AERONAUTICAL CHARTING FORUM
Instrument Procedures Group
Meeting 12-01 – April 24, 2012
HISTORY RECORD

FAA Control # 12-01-301

Subject: Publishing a Vertical Descent Angle (VDA) with 34:1 Surface Penetrations in the Visual Segment (*Also includes Issue 13-01-309 - LP Procedure Cancelled Because of VDA Not Being Charted*).

FAA Control # 13-01-309

**ORDER 8260.3, VOLUME 1, VISUAL PORTION OF FINAL
PENETRATIONS:**

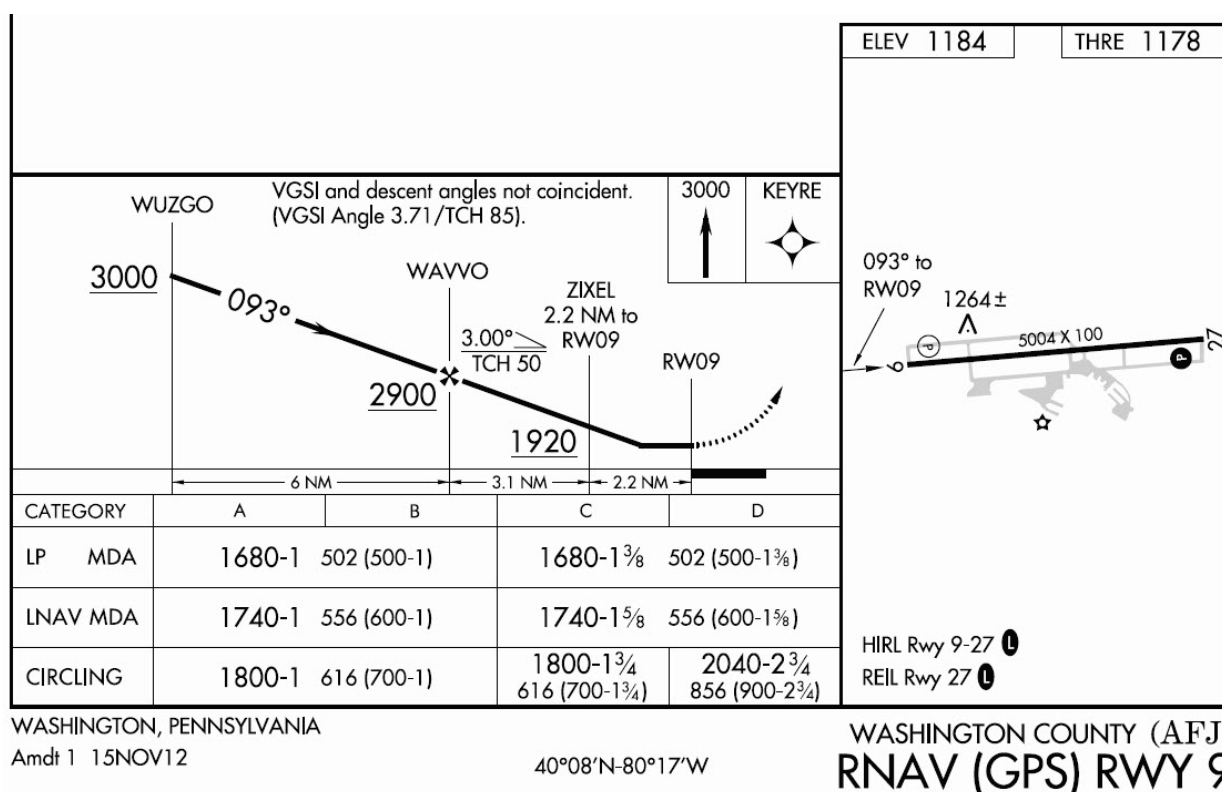
I called the Quality Advisor involved in the discussion to make sure I understood what was going on. He confirmed that the LP could not be published because it could not be coded with a VDA of 0 (zero). He indicated that the 0 was required to prevent advisory vertical guidance on the procedure.

I have several issues with this. The purpose for LP procedures is to provide a lower MDA than permitted by the LNAV where the smaller OCS footprint allows. It is only used when a vertically guided procedure isn't appropriate for the runway. Although a Constant Angle Non Precision Approach (CANPA) may be desirable, it is not always available as an option on all NPA procedures. The advisory glidepath provided by some manufacturers' GPS units is only permitted to be used during the descent to the MDA and not below it. It is my understanding that regardless whether a VDA is published or not, advisory vertical guidance may be provided, in that if the 8260 doesn't provide the data for the advisory glidepath, the manufacturer may calculate one. Therefore, setting the VDA to 0 in the database doesn't necessarily eliminate the advisory glidepath from the database. Because of the coding issue described by the Quality Advisor, the LP procedure is eliminated. It is ironic that the unintended consequence is that the LNAV will end up with an advisory glidepath, but if it is coded in the database it will not generate advisory guidance, at least in the Garmin units. This is because, the LP procedure in the Garmin units don't support advisory vertical guidance under any circumstance whenever LP is the highest service level coded for the approach, regardless if the integrity at the time of the approach supports LP or LNAV. My understanding of the ACF issue dealing with VDA was only to affect whether or not the VDA would appear on the chart and there was to be a note added to the effect "Descent Angle NA". This situation ends up being a 'catch 22', if the runway doesn't qualify for vertical guidance, and flight testing indicates that CANPA is not an option, it doesn't qualify for LP, and when a LP is coded it doesn't have advisory vertical guidance, but if only a LNAV is coded, it does have advisory vertical guidance.

Recommendations: The database coding of LP procedures should be permitted even when the VDA is not charted. Being able to fly a procedure with CANPA should not be a requirement for a NPA.
